— **Commission Energy 2030** —

Review Process

Answers to Questions 1-9 by Review Panels

Figure 1: Evolution of investment costs for some renewable technologies as used in the PRIMES database.

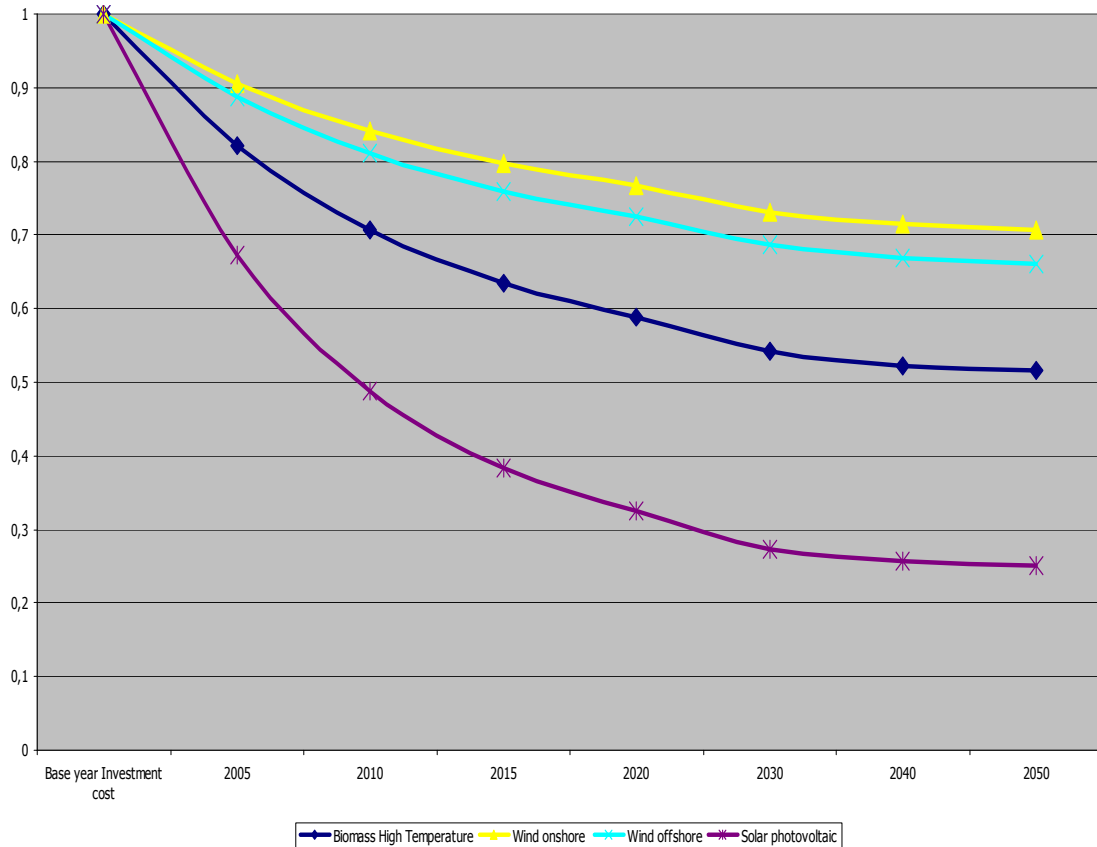
ODE Vlaanderen		
N°	Auteur	Questions
7	Jo Neyens	1. welke toekomstige kostendalingen afgeleid uit leercurves werden in het PRIMES model toegepast voor de diverse hernieuwbare energietechnieken?

The figure below shows the hypotheses as to the decrease in investment costs of four key renewable technologies.
